| Well Name: SAN JUAN 29-7 NP | Well Location: T29N / R7W / SEC 19 / SWNE / 36.714996 / -107.611038 | County or Parish/State: RIO ARRIBA / NM |

Subsequent Report

Type of Action: Cement Remediation

Actual Procedure: Hilcorp Energy completed cement remediation on the intermediate casing string. Shot perf hole @ 3730'. Pumped 60 sx squeeze cement, pressure tested with NMOCD witness (passed). Please see attached reports.

Current Schematic - Version 3

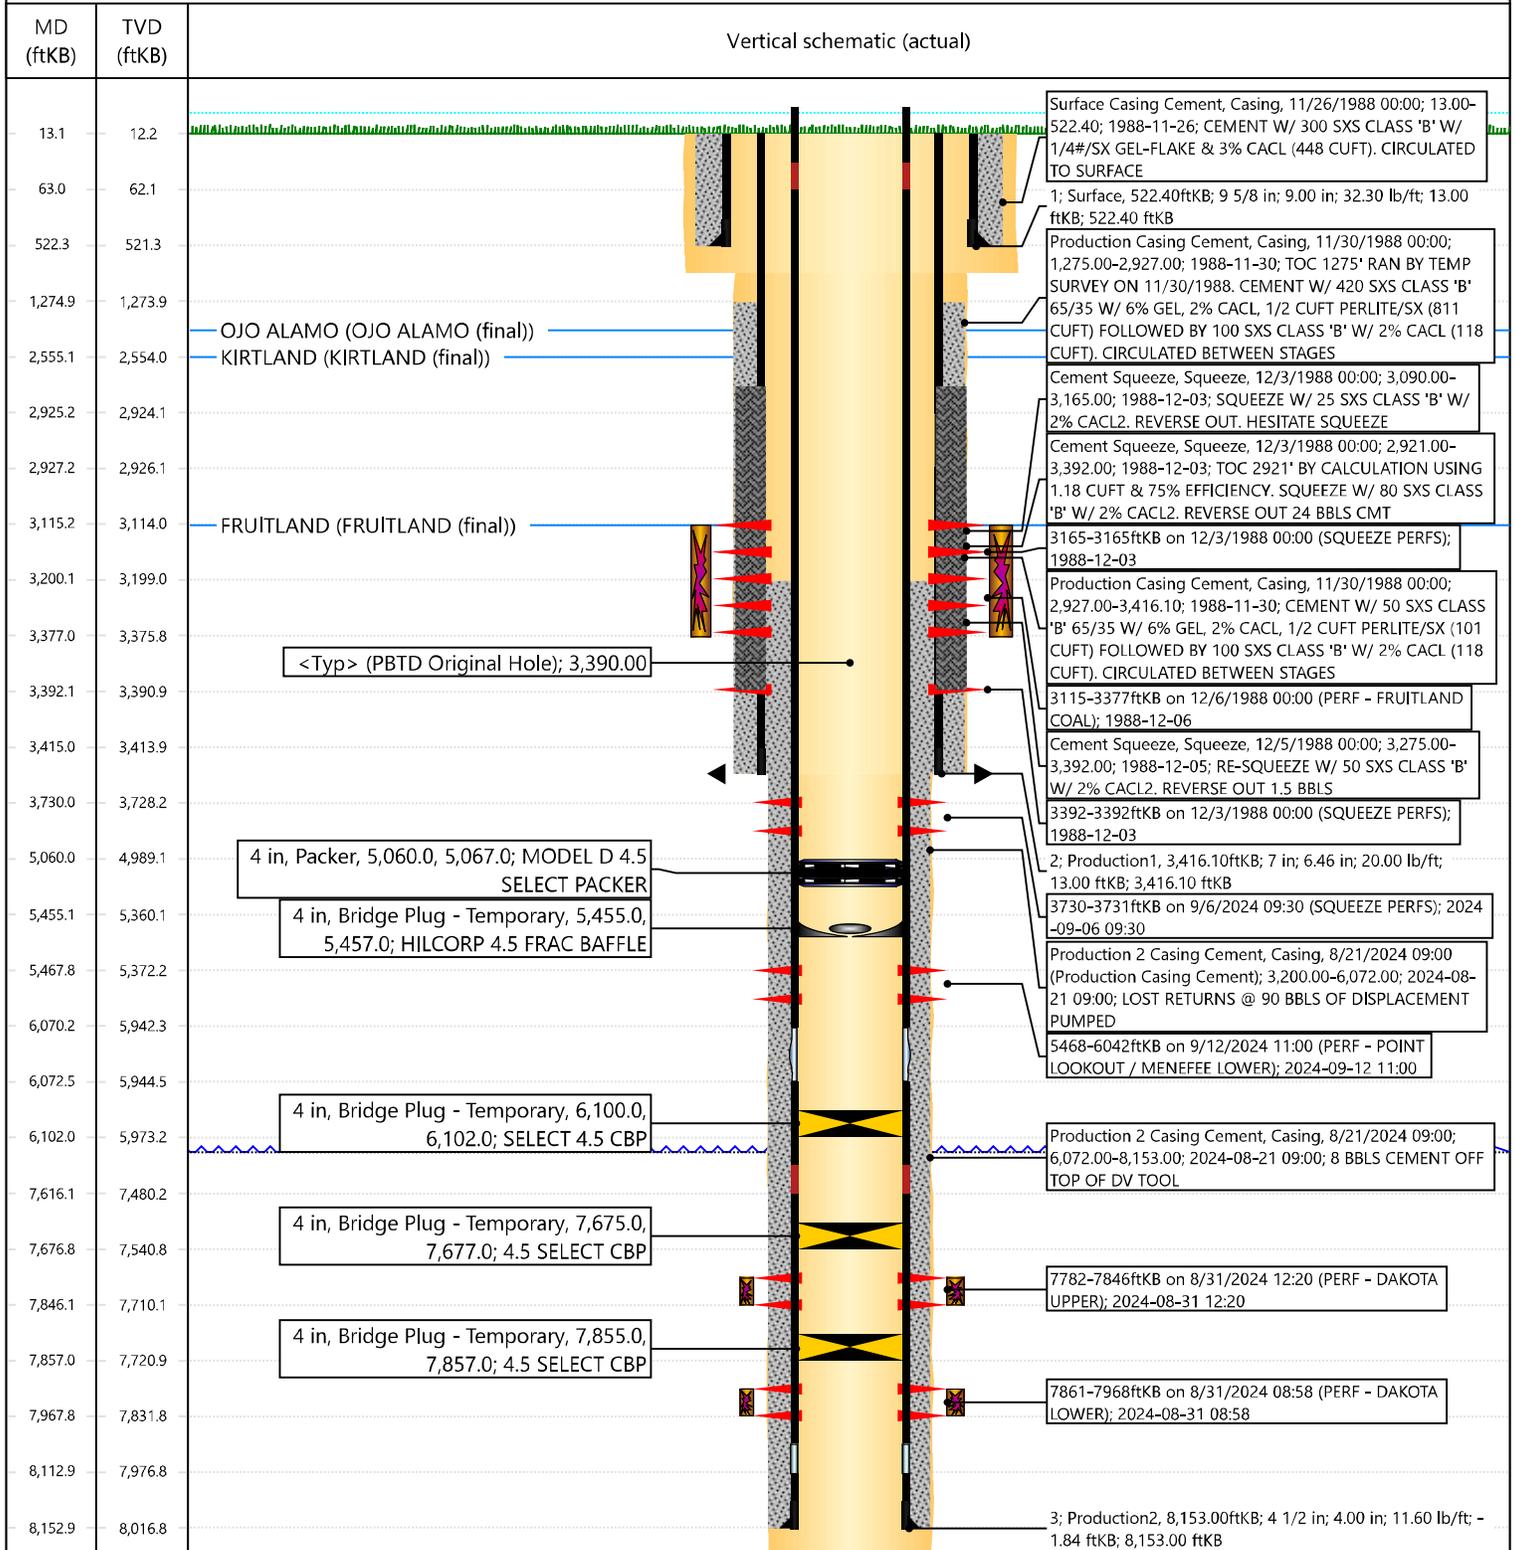
NMOCD requires cement from top of cement on 4 ½ by log ran 8/27/2024 – (toc looks to be around 3700 feet). Through shoe of intermediate at 3416 to 100 feet above fruitland coal perforations which is the top of fruitland coal formation (stated on Hilcorp schematic at 3115) -

In other words after all of that – cement needs to be ran from top of cement on 4 1/2 to 100 feet above fruitland coal perforations.

On the COA, it stated that is cement was not circulated to surface, then a CBL is required. Another COA stated that the TOC was to be 100' minimum over the Fruitland. It appears from you procedure that you want to perforate squeeze hole just above the shoe of the 7" and then pump a squeeze to cover the 7" shoe. The purpose for wanting cement behind your production string is for zonal isolation. I don't recall where the TOC is behind the production casing; however, where ever the TOC is, OCD wants you to perforate just above the TOC(< 50' above) and then circulate cement up to a minimum of 100' above the top of the Fruitland.

The BLM finds the proposed MV perforations appropriate.

CBL looks good. Good to proceed with MV completion.
